RE: Fill Permit – 15 King Street
(ID # 2007-0133) (CBL#297 E 36 to 39)

On October 25, 2007, the Portland Planning Authority granted approval for a fill permit at 15 King Street.
The City's approval is granted subject to the following conditions:

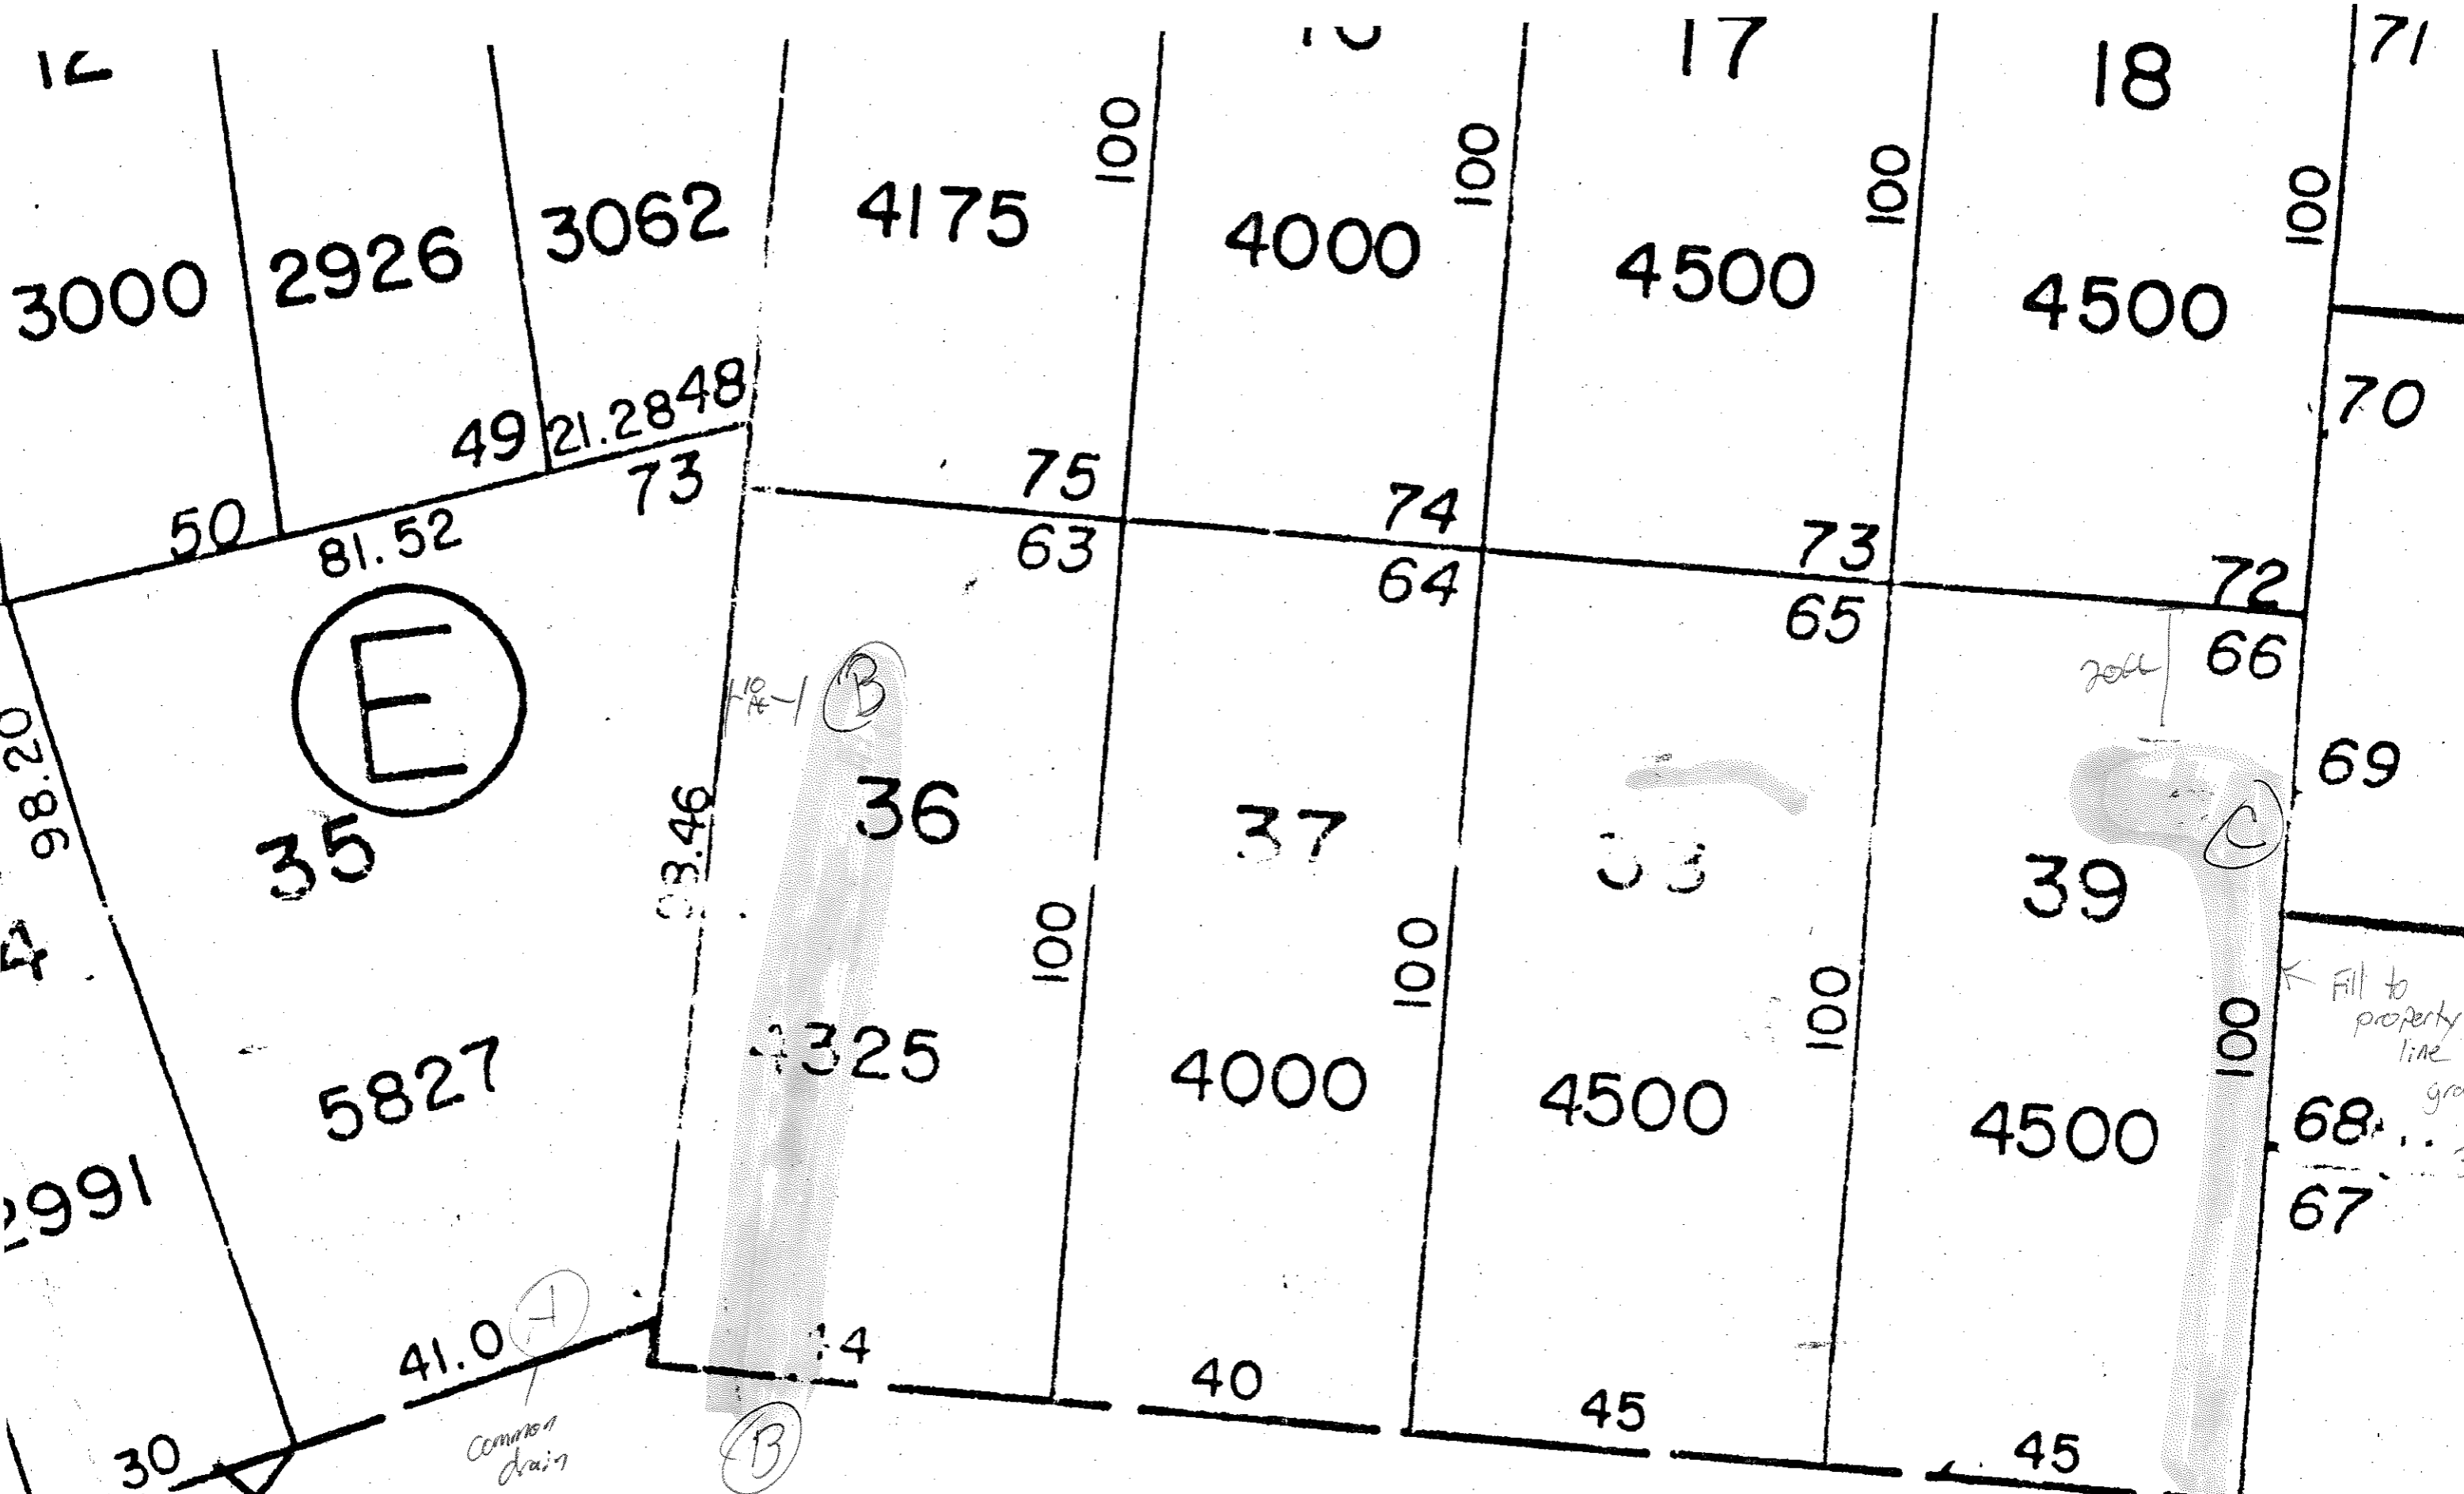
1. Applicant shall establish boundary lines around the perimeter of the property prior to commencement of filling the area.
2. Erosion and Sedimentation control shall be established prior to soil disturbance, and shall be done in accordance with Best Management Practices, Maine Department of Environmental Protection Technical and Design Standards and Guidelines.
3. All guidelines listed in the Fill Permit Application shall be followed.
4. All fill areas must be stabilized for winter by November 15, 2007.
5. The Development Review Coordinator reserves the right to require additional lot grading or other drainage improvements as necessary due to field conditions.
6. The expiration date of this approval is October 25, 2008.

The approval is based on the submitted site plan and scope of work discussed at the recent site visit/pre-construction meeting. If you need to make any modifications to the site plan, you must submit a revised site plan for staff review and approval.
